**RE: Sandia Area Credit Union and Starbucks, 11301 Montgomery Boulevard
Grading and Drainage Plan
Engineer's Stamp Date 6-01-2015 (File: F22-D002)**

Based upon the information provided in your submittal received 6-01-15, the above referenced plan cannot be approved for Building Permit until the following comments are addressed:

**SANDIA ARE FEDERAL CREDIT UNION/STARBUCKS
11301 MONTOMERY NE**

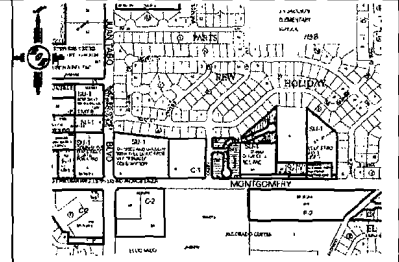
6) Provide a larger basin map. An 11x17 would be easier to read along with upsizing of the text for the labeling of the basins.

PROPOSED LAYOUT

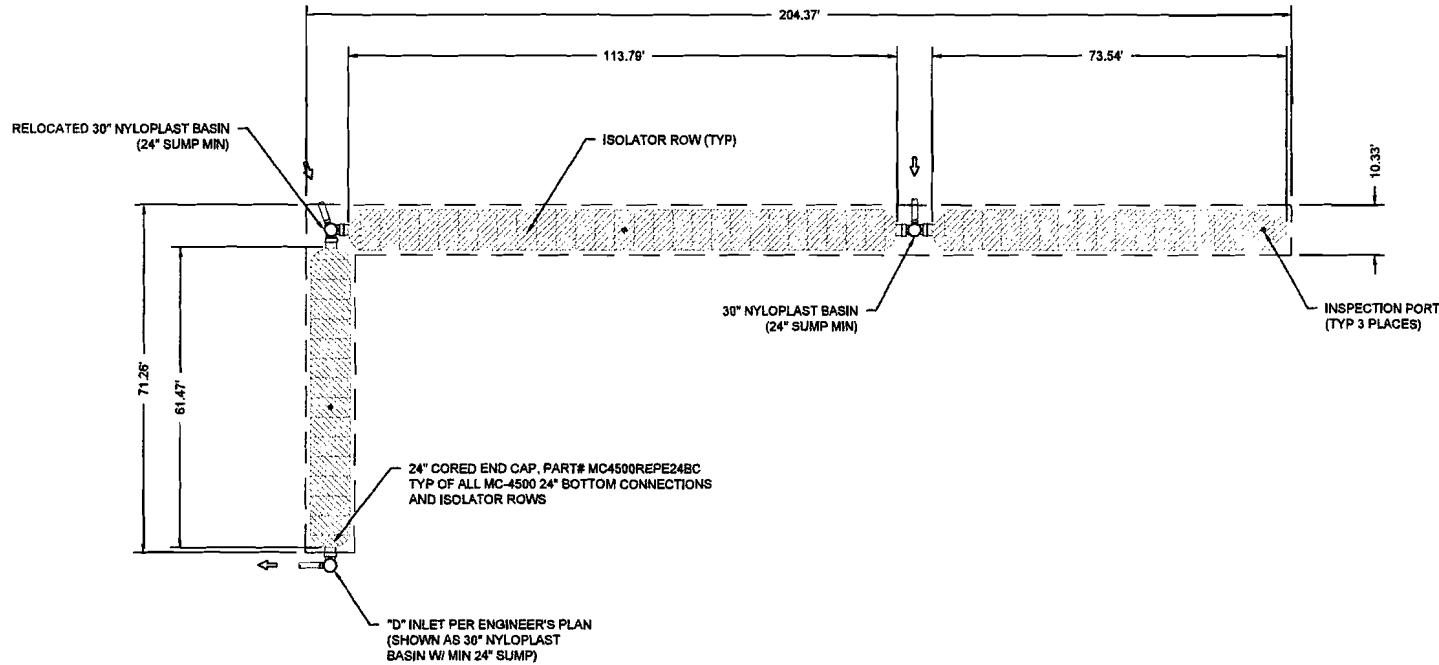
11) On the proposed layout for the storm chambers with the report, label the number of chambers used and the volume of each chamber. Then provide the overall volume of the chamber on this sheet and on the plan view. Provide a cross-sectional view of the storm chamber similar to what is shown on the report showing a detail of the stone and fabric surrounding it if it is just for one row. (It should be similar to the cross-section provided in the report for the multiple chambers.)

Safca & Starbuc GRADING AND DRAINAGE PLAN	DRAWN BY DEM DATE 8-14 Safca & Starbuc 000 Planning
		SHEET # 1 of 1 JOB # XXXXX
3/17/15 DAVID SOULE P.E. #14522

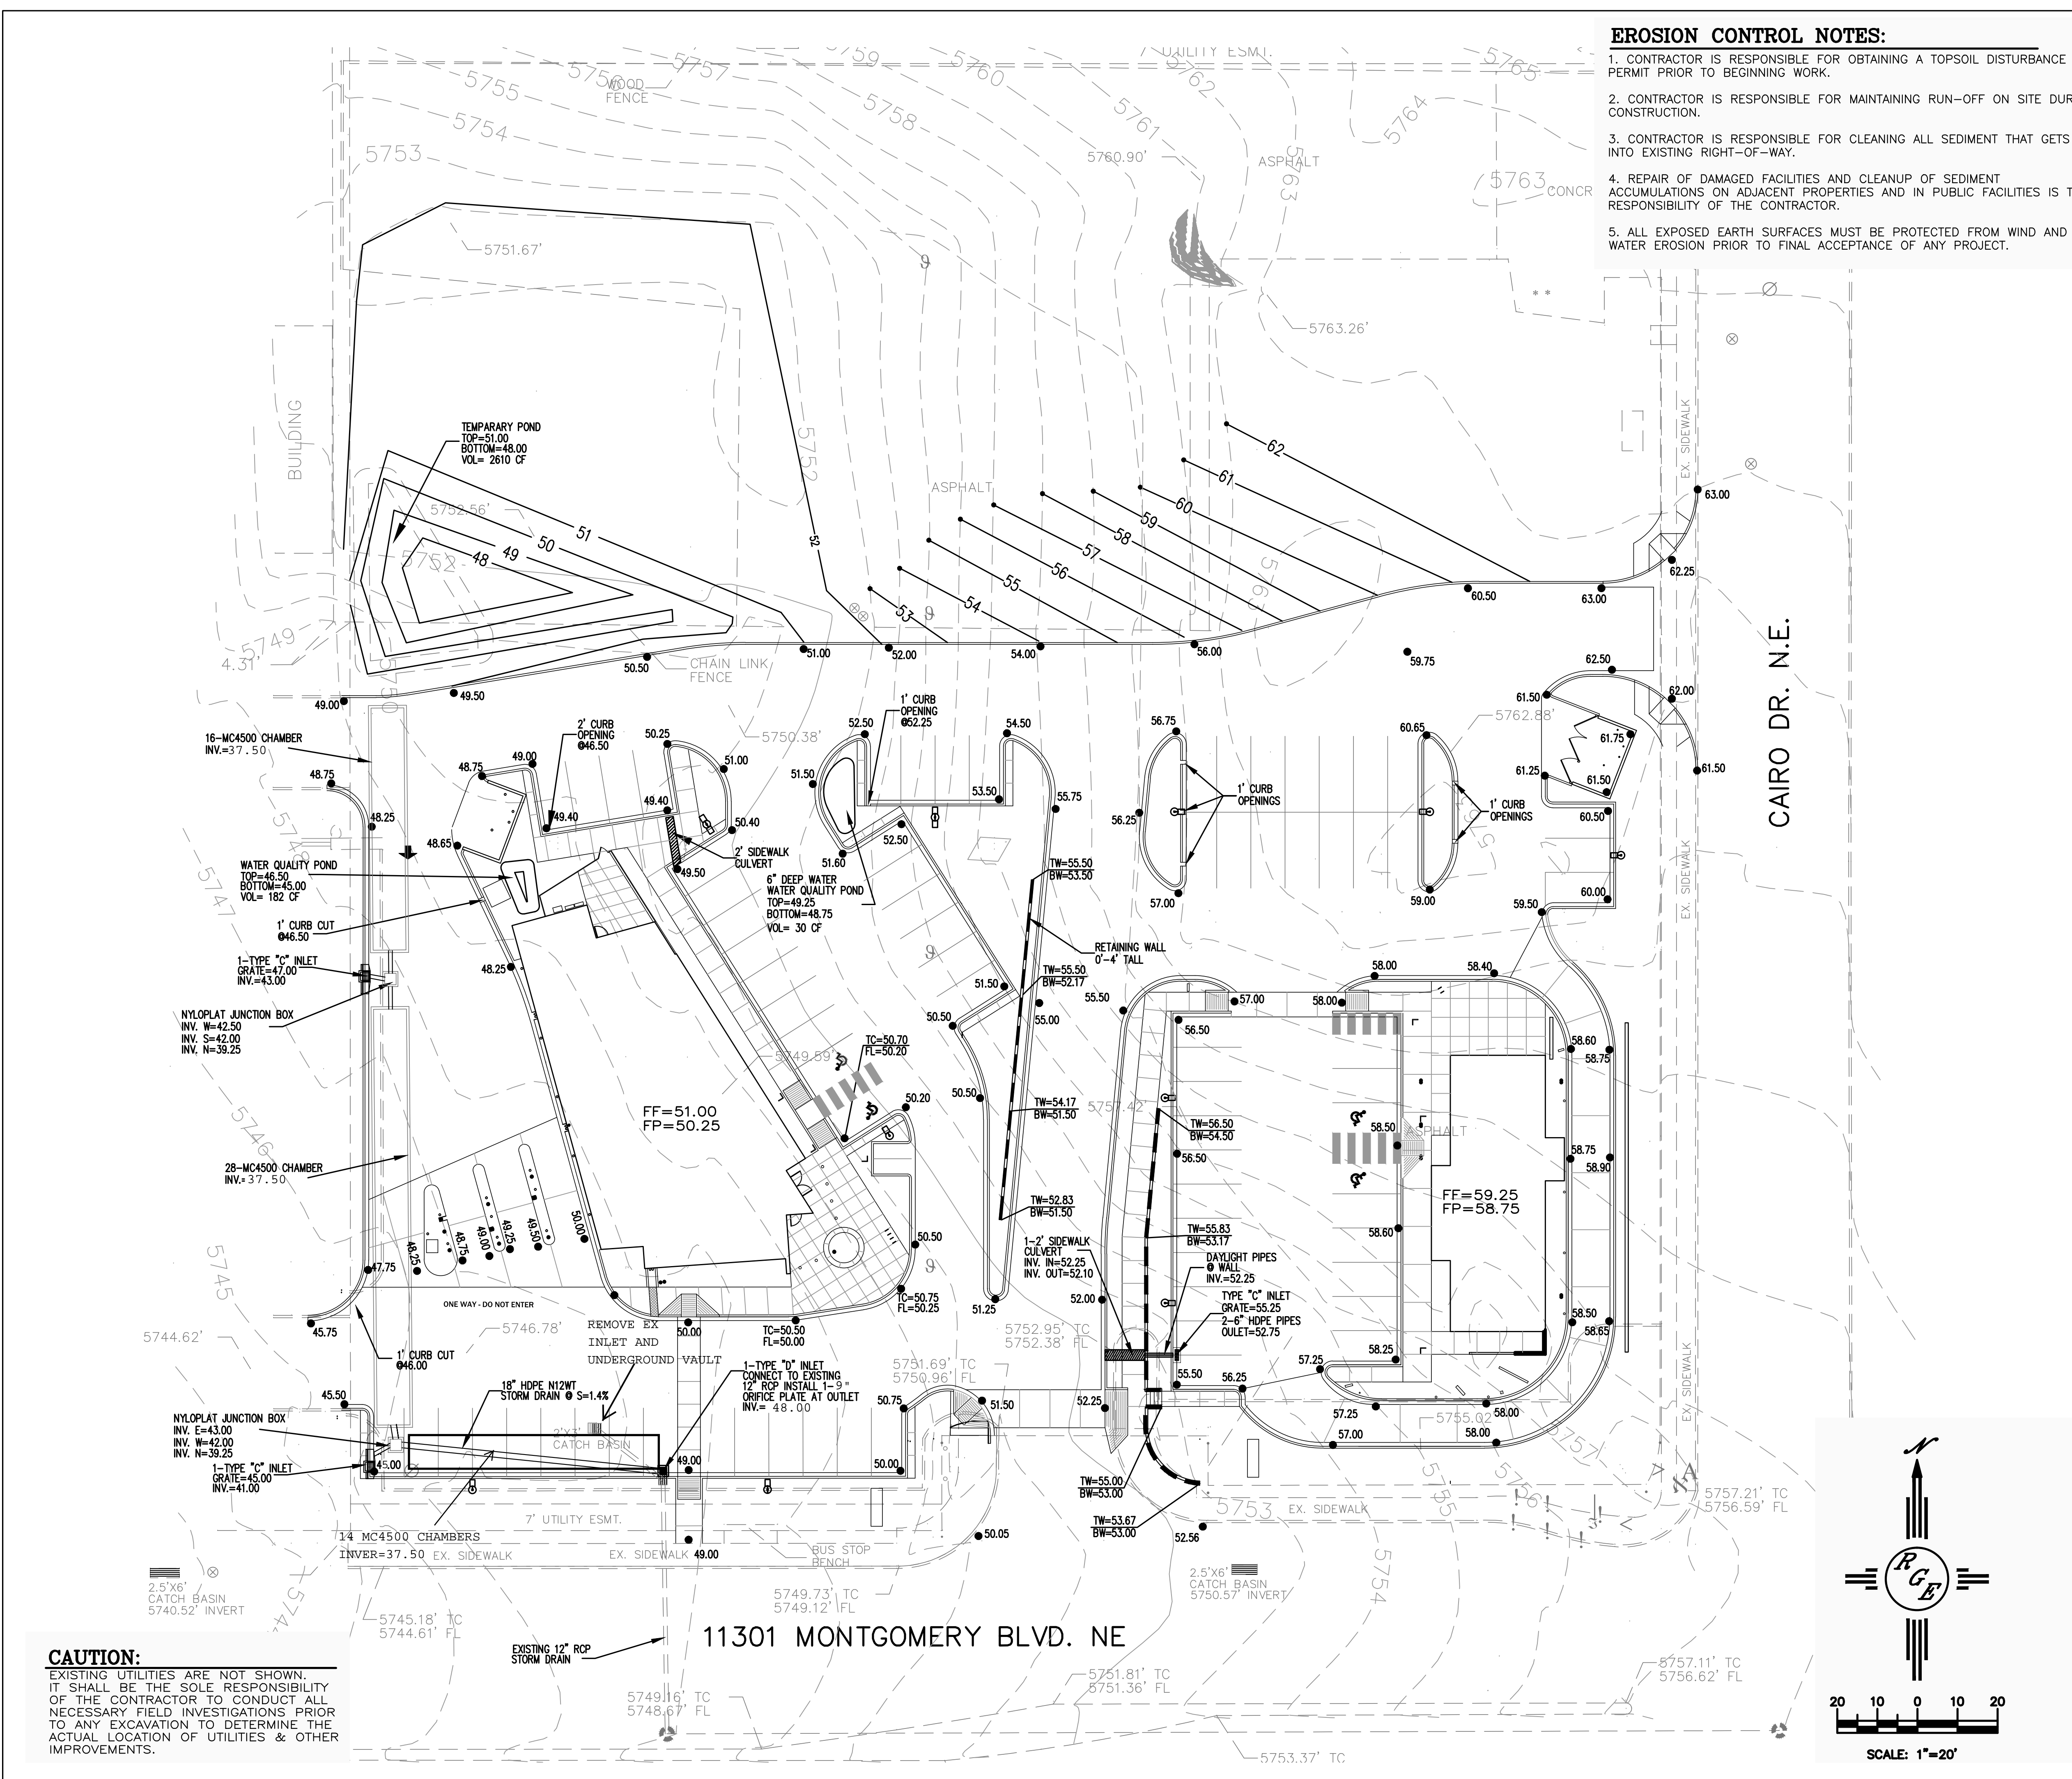
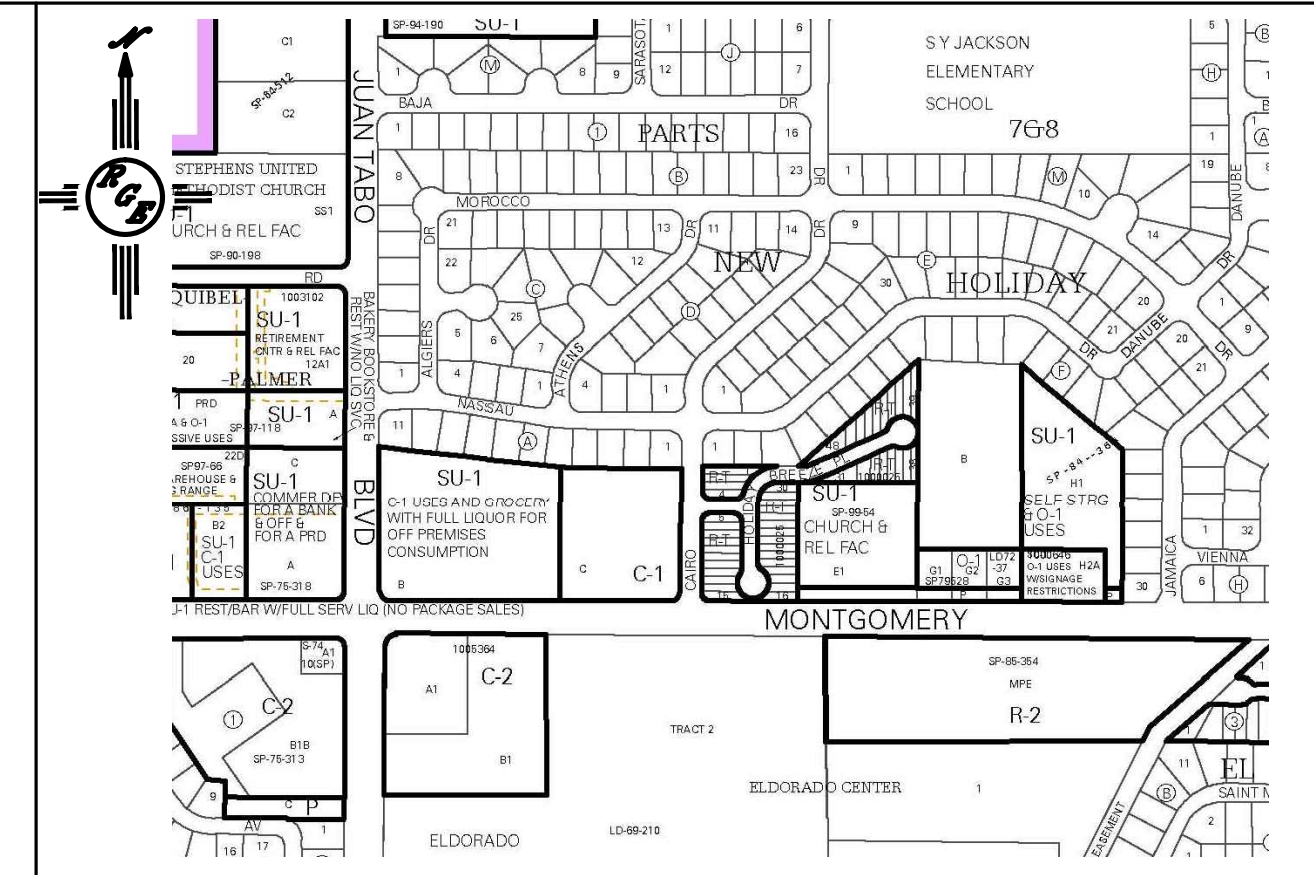
- 1) Show first flush calculation within the report. Show roof drain locations, and explain how first flush is being managed especially with regard to impervious facilities on the east side of the site. It appears as though an additional first flush pond may be needed to handle first flush from the building on the southeast corner of the site with added curb cuts to allow drainage into the pond from the drive-thru area. Label all first flush ponds as "first flush" along with volume information.

- 2) Show flow arrows and lot lines on the grading and drainage plan.
- 3) What are the curb cuts in the medians to the north of the Starbucks for? If a first flush pond was intended here, label it, and provide elevation and volume information. Provide curb flowline elevations at all curb openings.

- 4) Show existing curb elevations on Cairo at the access point, and show existing elevations along west property line to show how these existing elevations relate to new elevations. On the north side of the site, provide elevations for the existing building that abuts the property line, and ensure that the new contours tie into the correct existing contours.

- 5) Discuss what the temporary pond is for. What is the sizing of it based on since the 100-year 6-hour volume is much higher for Basin A? Discuss what the plans are for Basin A since an impervious area of 0.988 acres was given in the computations.

Also provide riprap within the proposed swale to the bottom of the pond from the east to prevent erosion.

7) Label grate elevation for the new Type "D" inlet. Provide a detail showing all elevation information for inlet including information for orifice. Show how this inlet ties into the storm chambers with pipe invert and size information.

8) Label size of Nyloplast junction boxes and the pipes that tie into the storm chambers. Between the high invert elevation of 48.00 for discharge from the site and the high invert elevations of the connecting nyloplast junction boxes, how does the entire system manage to drain, given that the top of the storm chambers are set at elevation 42.50??

13) North of the credit union building, there is a curb cut elevation at an elevation of 49.40 which should be lowered if the intent is to drain to the "water quality pond". Also, the nearby "water quality" pond is labeled at an elevation of 46.50 for the top elevation. Correct discrepancy. Also, provide additional elevation information for the corners of the trash receptacle area.

14) If the proposed elevations shown are at flowline, provide general note to this effect.

16) Provide a small valley gutter from the sidewalk culvert from Starbucks across the accessway to prevent flow from discharging out the accessway.
